Subject: **Vermont Yankee Nuclear Power Station**
License No. DPR-28 (Docket No. 50-271)
Technical Specification Proposed Change No. 244
Revised P/T Curves and
Exemption Request to use Code Cases N-588 and N-640

Vermont Yankee Nuclear Power Station

Proposed Technical Specification Change No. 244

Revised P/T Curves

FIGURE 3.6.1

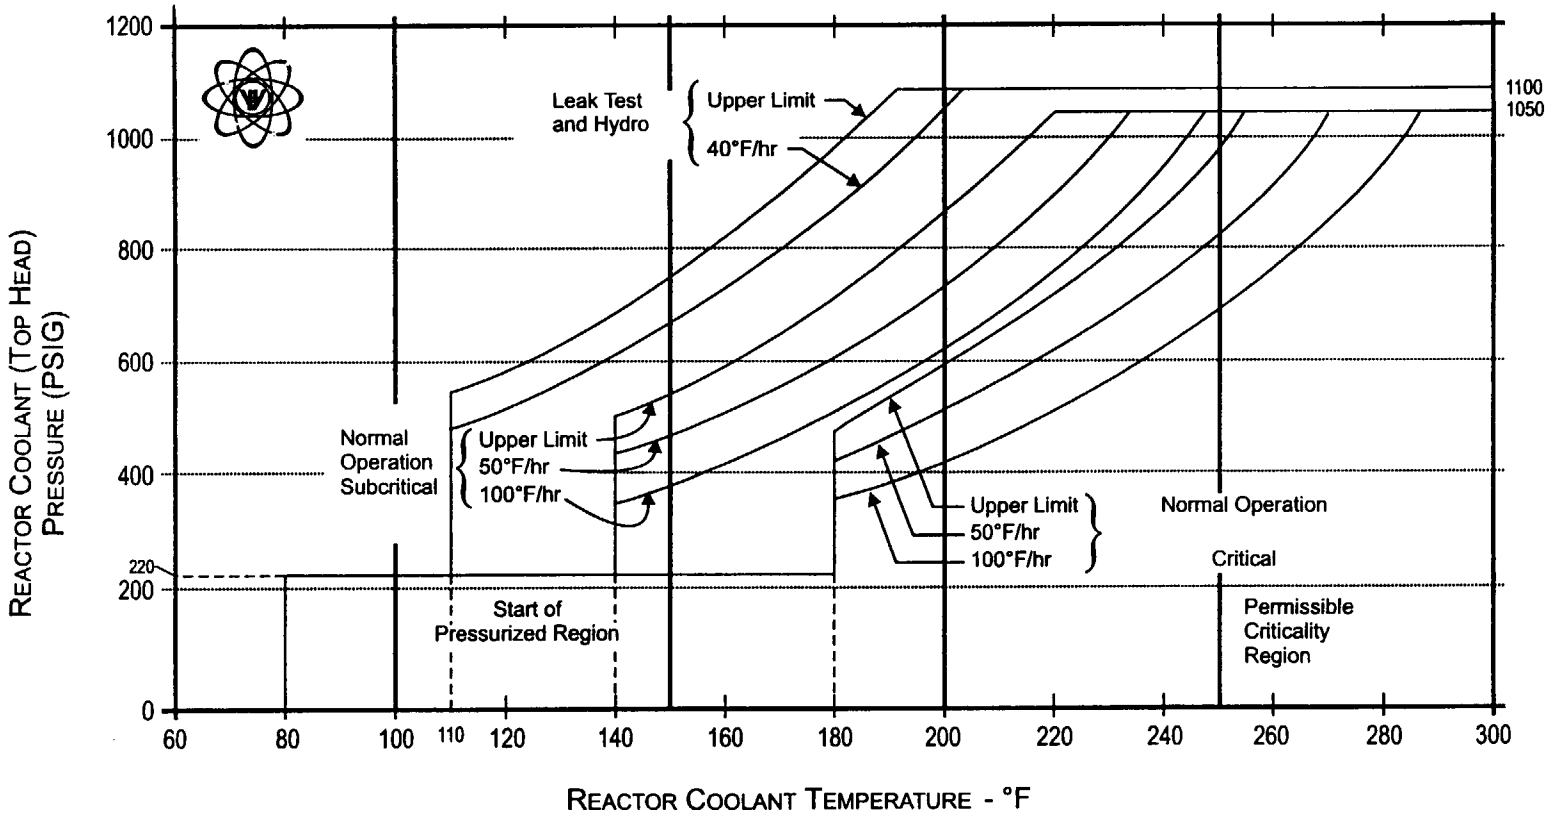
In this proposed change, Technical Specification Figure 3.6.2 "Fast Neutron Fluence (E>1 MEV) as a Function of Thermal Energy and Full Power Years" and Figure 3.6.3 "Fluence Factor for use in Regulator Guide 1.99, Revision 2," have been replaced with the P/T curves for Core Not Critical and Core Critical Operation. The current Figure 3.6.2 provides beltline fluence values at the vessel surface as well at 1/4T and 3/4T as a function of full power years. However, these curves are not utilized in the development of our proposed curves. The proposed P/T limits were calculated utilizing an end of life fluence value. Accordingly, the current Figure 3.6.2 is being replaced. Figure 3.6.3 is a copy of the fluence factor curve from RG 1.99, Rev 2. It has an additional line demonstrating VY's conservatism from our previous submittal (see footnote 1). Since these curves were not utilized in the development of our current P/T limits, the figure is being removed from the specifications.

Figure replaced in entirety

FIGURE 3.6.3

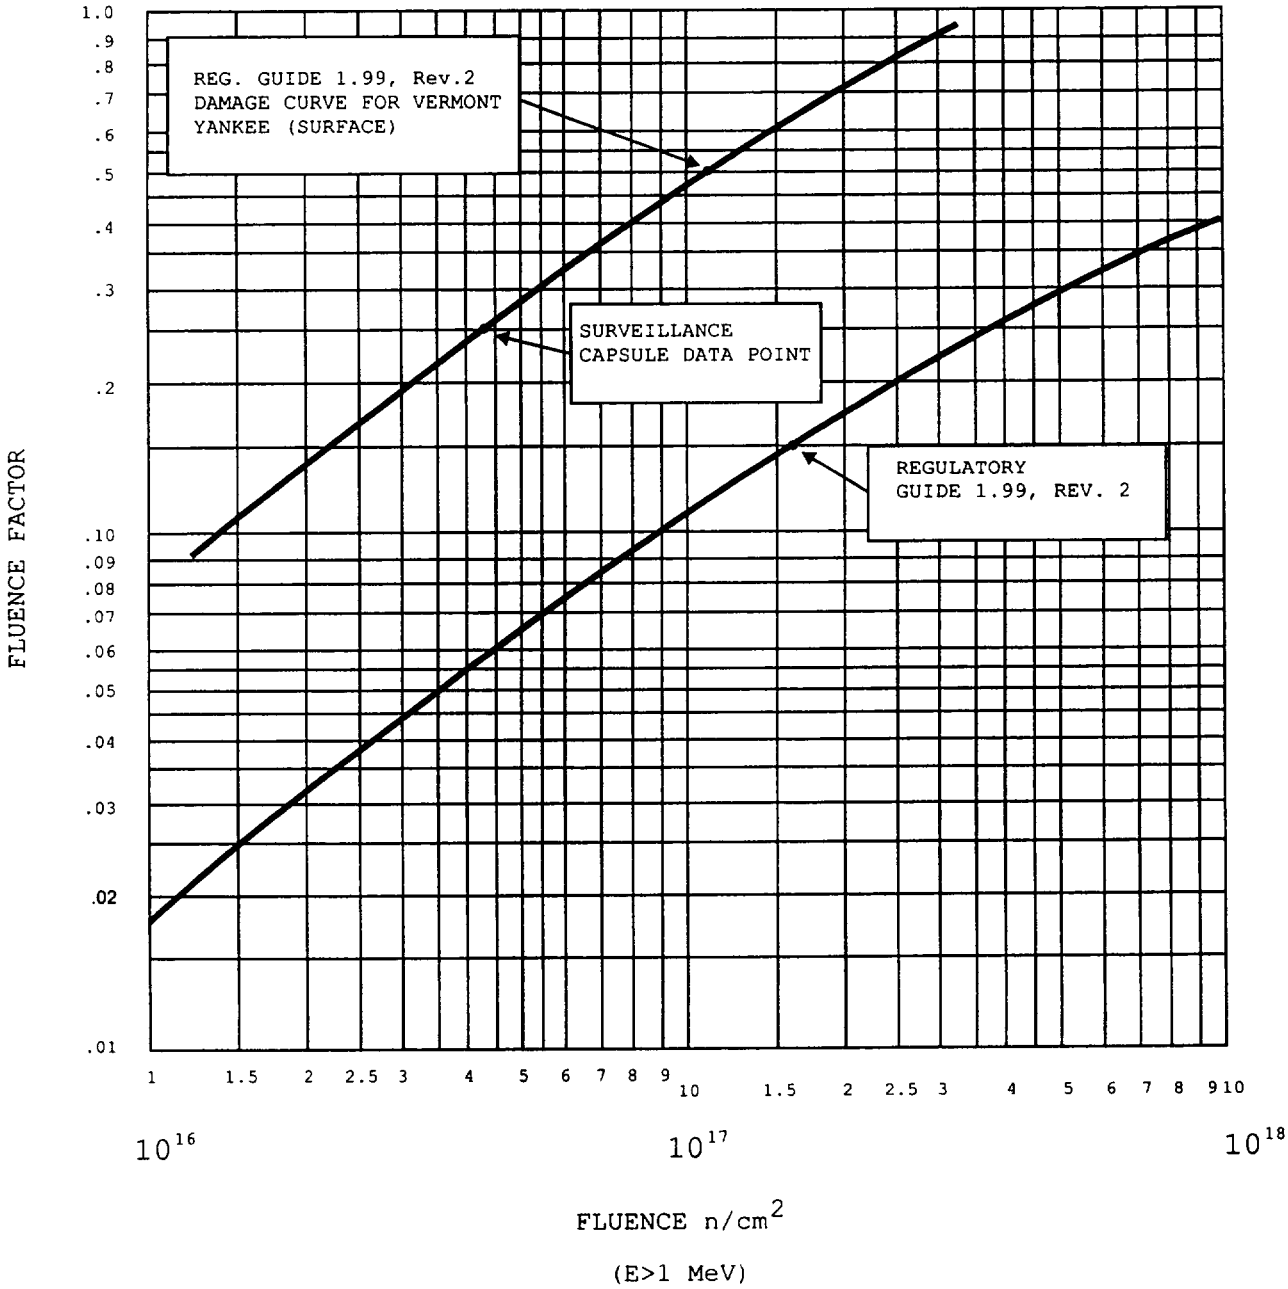
Figure Replaced In Entirety

FIGURE 3.6.1

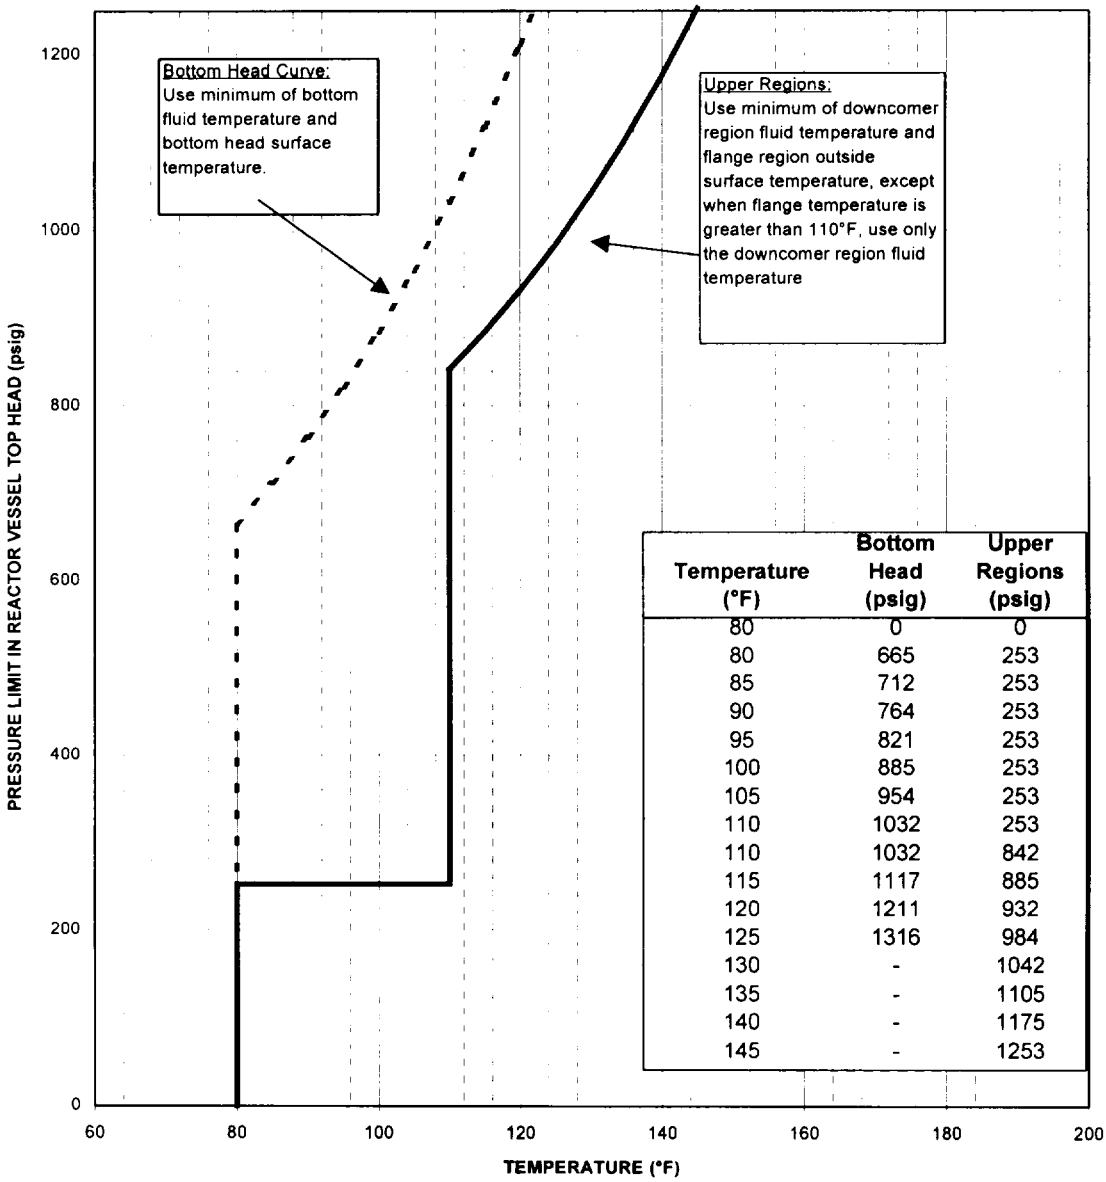
The proposed change would revise the reactor vessel pressure/temperature (P/T) limit curves specified in TS 3.6.A.1, "Reactor Coolant System - Pressure and Temperature Limitations," as graphically represented in Figure 3.6.1, for reactor heatup, cooldown, and critical operation, as well as for inservice hydrostatic and leak tests. Figure 3.6.1 would be replaced with three figures:

Figure 3.6.1, "Reactor Vessel Pressure-Temperature Limitations: Hydrostatic Pressure and Leak Tests, Core Not Critical,"
Figure 3.6.2, "Reactor Vessel Pressure-Temperature Limitations: Normal Operation, Core Not Critical," and
Figure 3.6.3, "Reactor Vessel Pressure-Temperature Limitations: Normal Operation, Core Critical."

Reactor Vessel Pressure-Temperature Limitations
Hydrostatic Pressure and Leak Tests, Core Not Critical

40°F/hr Heatup/Cooldown Limit
Valid Through 4.46E8 MWH(t)
